**TASMANIA DEPARTMENT OF MINES
UNPUBLISHED REPORT 1979/61**

Examination of a proposed subdivision at Windermere

Figure 1

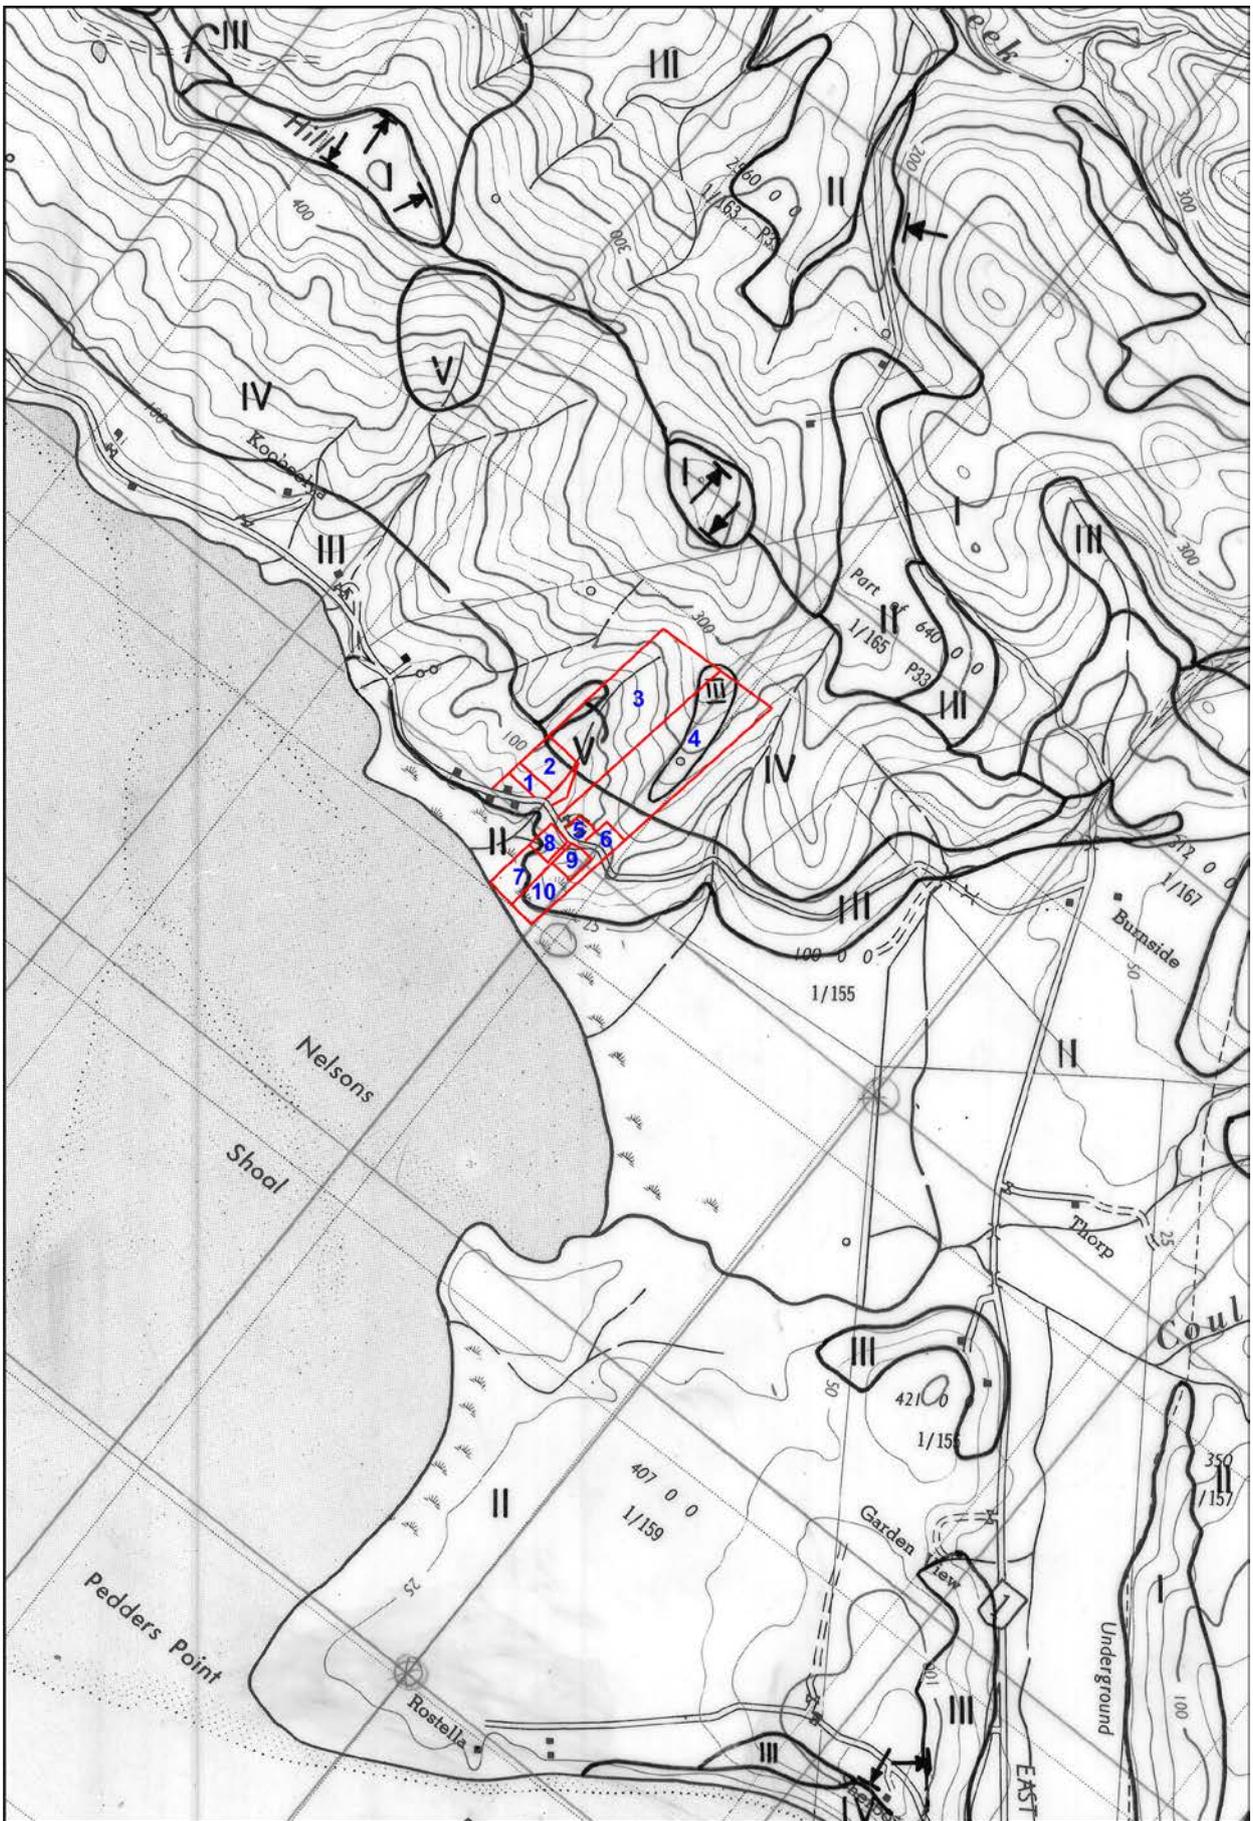
The subdivision outline has been transferred to the landslip zone map of the area (fig. 1). Much of the steeper land has been placed in class IV on the zone map, with most of the lower sloping land in Class III. It is not recommended that the Class IV areas be developed without detailed subsurface investigations. Development of the Class III areas appears reasonably safe provided that the flatter areas are developed and houses are not sited close to the steeper slopes. It is recommended that the landslip B building regulations be used as a guide in developing the Class III areas. An additional small area of Class III land (previously Class IV) has been outlined along the top of the ridge and occurs mainly on lot 4 but extends just on to lot 3.

Lot 1 already has a house on it. The best house site for lot 2 is the middle of the ridge on the western side. Lot 3 has a site large enough for a house site in the new Class III area. There is also some Class III land on the southern end of the lot in which it may be possible to site a house. Lot 4 has the major part of the new Class III area and if a house is proposed on it a site on the crest of the ridge should be selected. There is also Class III land on the southern end of this lot on which a site could be selected.

Lot 5 has an existing house. Lot 6 is all in Class III but is fairly steep over all of the block. Particular attention should be taken to ensure very good surface drainage and deep cuttings around the slopes should be avoided. Lots 7, 8, 9 and 10 have fairly flat areas as well as steeper sloping parts. House sites should be selected on the flatter areas and not near the steeper land.

Stormwater, sullage and septic tank water should not be allowed to discharge directly downslope and near to the house sites. Ideally this water should be piped around the slope from the houses and allowed to discharge some 25–40 m from them. This applies particularly to lot 6.
